Remediation System Evaluation (RSE) Moss-American Superfund Site

Milwaukee, Wisconsin

**Final Report
March 2011**

Prepared by:
US Army Corps of Engineers
Environmental and Munitions Center of Expertise
and
Seattle District

Figure A-5. Small Scale Re-Circulation Cell, Excavation at MW-34S

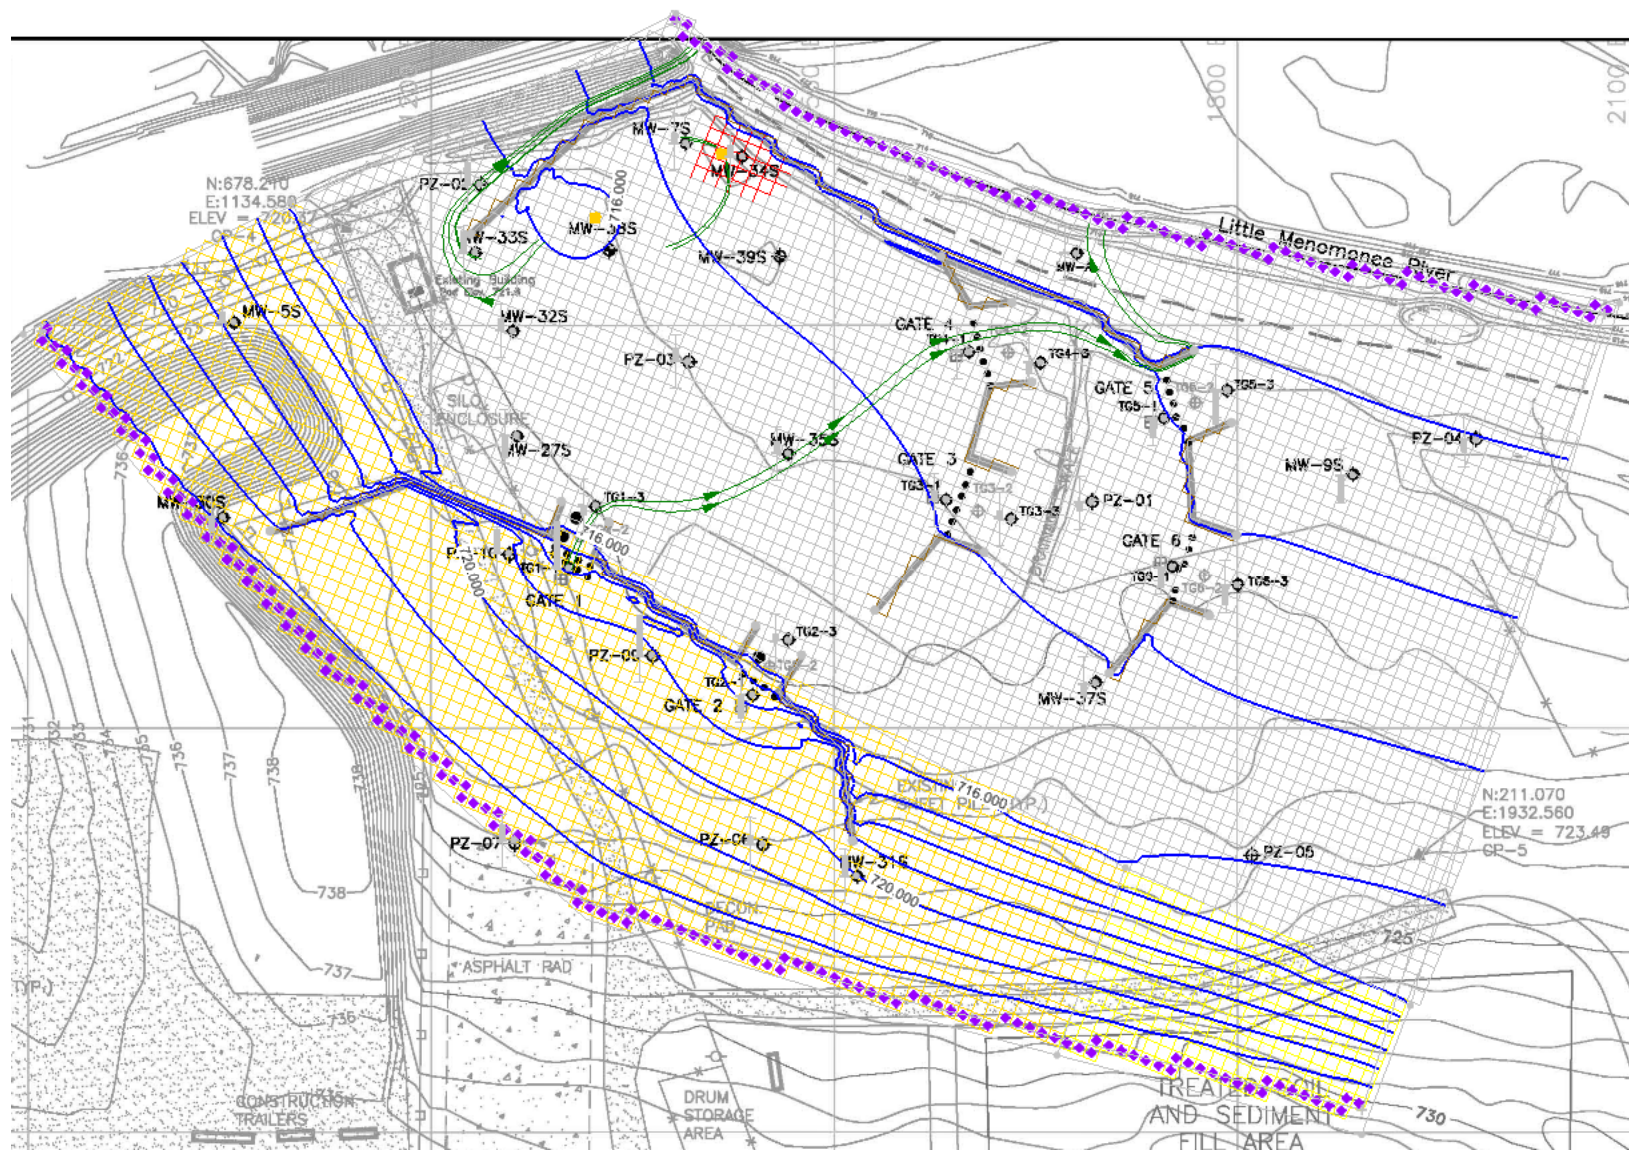
Figure A-5 shows the groundwater elevation contours for the small scale re-circulation cell and excavation at MW-34S. This scenario includes excavation of NAPL containing soils around MW-34S (shown in red on Figure A-5) and backfill with sand and ORC. In addition, a small re-circulation cell would be installed in the north east portion of the system to help distribute ORC to the dissolved phase plume. An extraction well would be installed near MW-34S and an injection well would be installed near MW-38S. Due to the low permeability soils near this area, pumping/injection would be very low (0.5 gpm). The model shows that this type of circulation cell could adequately distribute ORC throughout the remaining dissolved phase plume, however, there will likely be some groundwater mounding near MW-33S that could increase the amount of flow around the end of the sheetpile wall. Additional costs may include treatment of contaminated groundwater prior to re-injection.

Figure A-6. Groundwater Extraction near Gate 5 and 6, Excavation at MW-34S

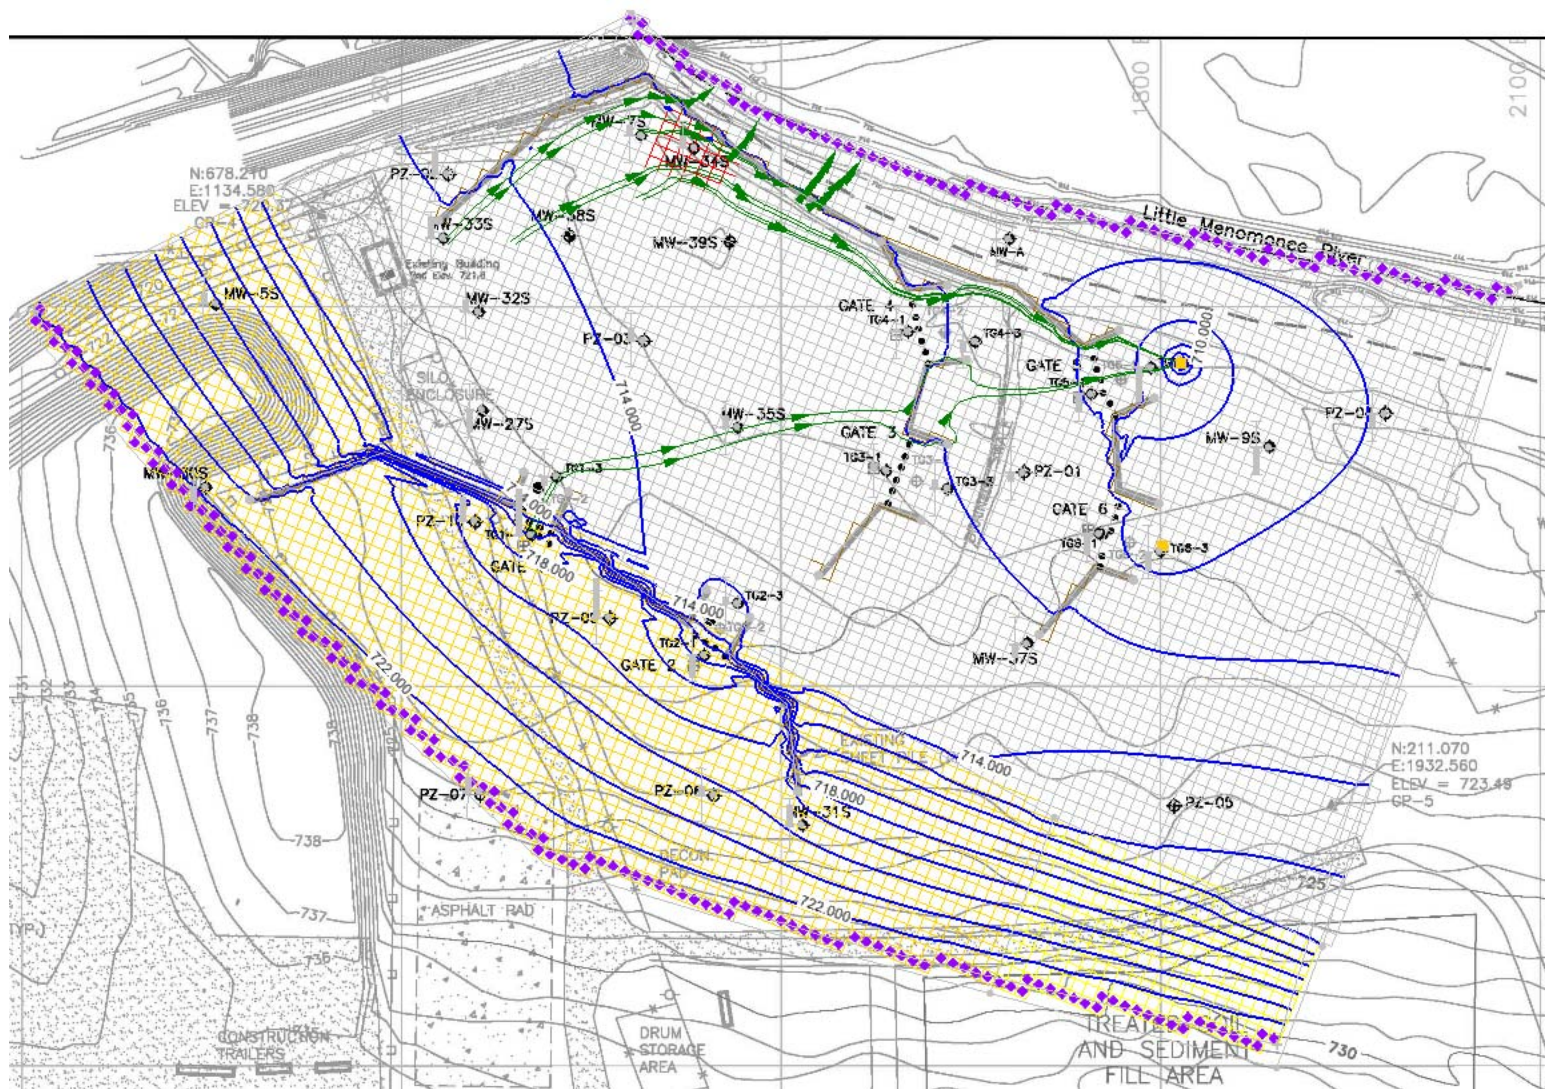
Two model scenarios were evaluated: 1) installation of extraction wells down-gradient of Gates 5 and 6 and 2) installation of a large scale re-circulation cell that includes an injection well near MW-7S and an extraction well down-gradient of Gate 5. The groundwater model shows that even with extraction wells, the groundwater stagnation area may still exist (Figure A-6). The extraction wells induce a slight gradient

Figure A-6 shows the groundwater elevation contours for groundwater extraction near Gates 5 and 6 and excavation at MW-34S. This scenario includes excavation of NAPL containing soils around MW-34S (shown in red on Figure A-6) and backfill with sand and ORC. Two groundwater extraction wells would be installed east of Gates 5 and 6. Due to the low permeability materials, groundwater extraction rates would only be about 0.75 gpm near Gate 5 and 0.25 near Gate 6. The model shows that the groundwater stagnation area near MW-7S and MW-34S still exists, however, flow no longer goes around the end of the sheet pile near MW-33S and groundwater near MW-38S will eventually reach the eastern treatment gates. Since the gradient is very low, it may still take over 30 years for the contaminated groundwater to reach the eastern treatment gates.
